From: [Krueger, Paul W \(UCO\)](#)
To: [SR 520 DEIS Comments](#);
CC: [Swenson, Michael/BOI](#);
Subject: FW: SR 520 Replacement
Date: Tuesday, October 03, 2006 9:08:04 AM
Attachments:

SR 520 Bridge Replacement and HOV Project

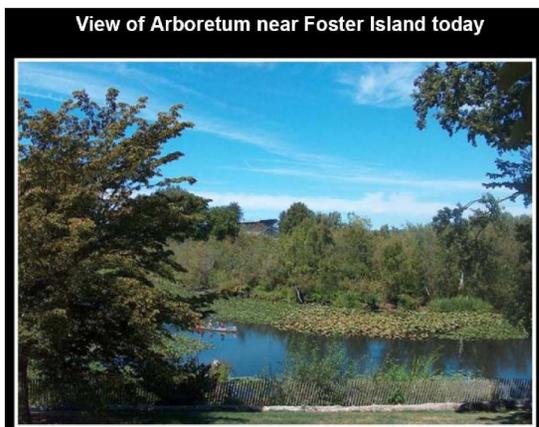
I-0502-002 There is evidence that a combination of a cut/cover tunnel and a shallow tube tunnel through this critical area is both feasible and economically viable. This option needs further study, and I urge you to endorse this study so all stakeholders can make educated decisions balancing our transportation demand and our natural environment.

I-0502-003 As any long-time Seattle resident knows, sound travels far over water. Therefore the portions of highway that must be located above grade (and regardless of which replacement option is selected), must have sound walls and perhaps also a landscaped sound lid. These components should extend not just through the arboretum, but should begin west of Montlake Park and continue past Webster Point and Madison Park, where eagles and other shore birds live, hunt and breed.

Now imagine Union Bay and Montlake with 520 lidded and tunneled...

See Section 1.1 of the 2006 Draft EIS Comment Response Report.
